APPLICATION NO.	FILING DATE	FIRST NAMED INVENTOR	ATTORNEY DOCKET NO.	CONFIRMATION NO.
10/692,481	10/23/2003	Philip Berardi	I008-P03170US	1998

Office Action Summary

This is the first office action for application number 10/692,481, Mount for Stage Apparatus, filed on October 23, 2003.

Claims 1-4, 6-16, 18-24, 26, 27, 29-34 are rejected under 35 U.S.C. 102(b) as being anticipated by U.S. Patent number 5,199,836 to Gogarty.

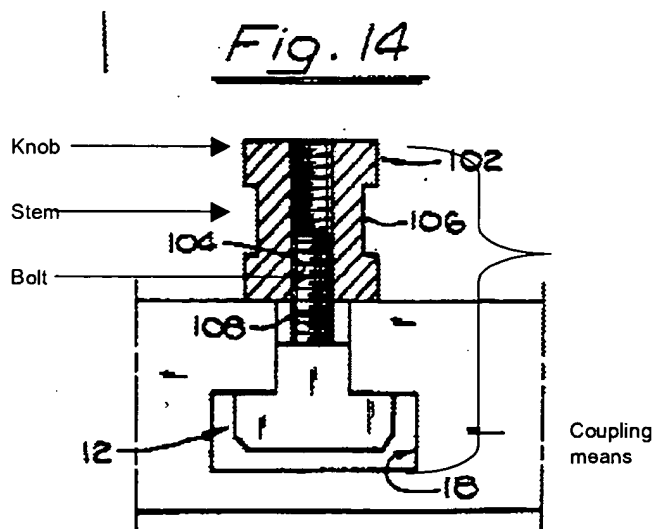
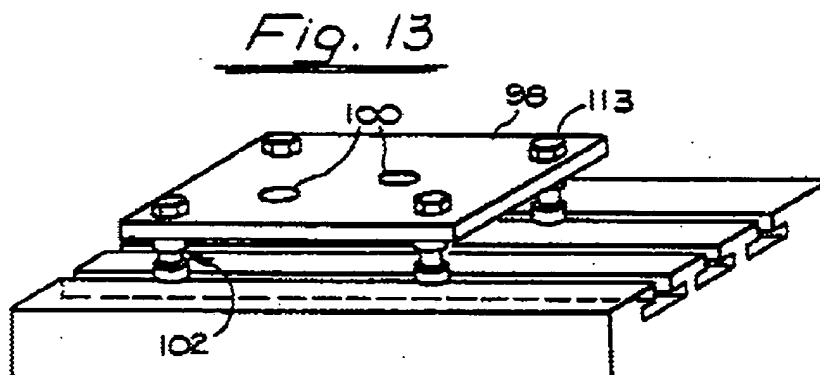
Gogarty '836 discloses a support mount (above) comprising accepting means comprising a base plate (98), and coupling means (above) comprising a cylindrical portion (108) that is rotationally activated, wherein the coupling means comprises a t-bolt (12), wherein the coupling means includes aligning means (30, generally, see figure 1) that is rotationally activated, wherein the support mount includes a cylindrical mount device permanently attached to the base plate (100, hole and inside wall are a "mount device"), wherein the support mount includes a knob assembly/stem assembly including a knob, circular stem and a bolt/t-bolt (above), wherein the knob is permanently secured to the stem, wherein the bolt/t-bolt is secured into a cavity in the stem, wherein the cavity includes screw threads complementary to screw threads included on a cylindrical portion of the bolt, wherein the bolt comprises a head, collar and cylindrical portion (28, 30, 108), wherein the head forms a T-shape with the collar and the cylindrical portion, wherein the collar is a shape that serves as a cam when the bolt is rotated, wherein the head inherently becomes perpendicular to a channel opening in a rail, wherein the cylindrical portion includes screw threads complementary to those included in the stem, wherein the support mount is to be attached to a rail via rotating the knob (inherently), wherein the support mount is inherently attachable to a rail via placing the head(s) of the t-bolt(s) into a channel in a rail (see figure 13) and rotating the knobs so as to inherently cause the cylindrical portion to be drawn into a receiving cavity in the stem as the head becomes flush with the underside of lips of the channel in the rail as some pin body is secured against the top of the rail.
